Product Change Notification: P-16-013435

SHIELD FINGER 1210

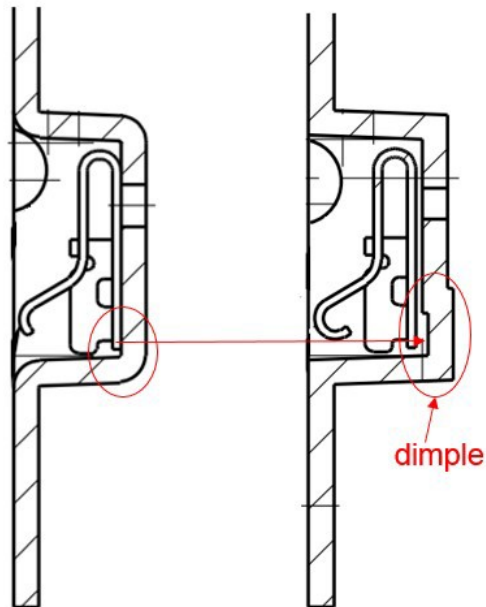
Add a dimple on the bottom of emboss. Package quantity keep the same.

add dimple on the bottom of emboss

Product improvement. Keep spring finger edge away from emboss bottom avoid spring finger locked in emboss type.

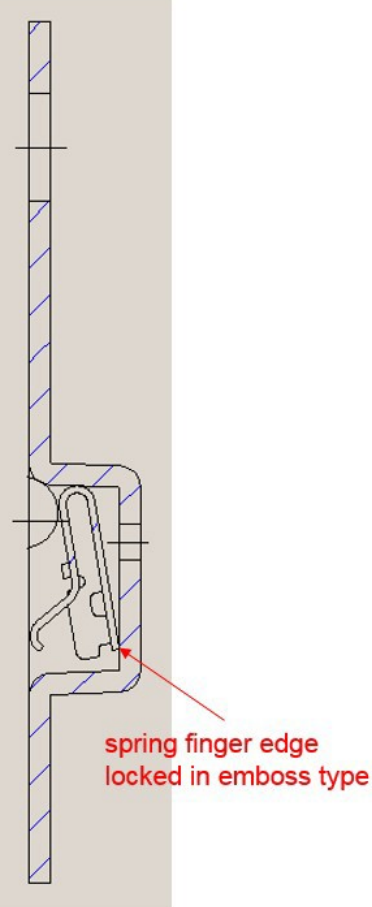
spring finger locked in emboss type
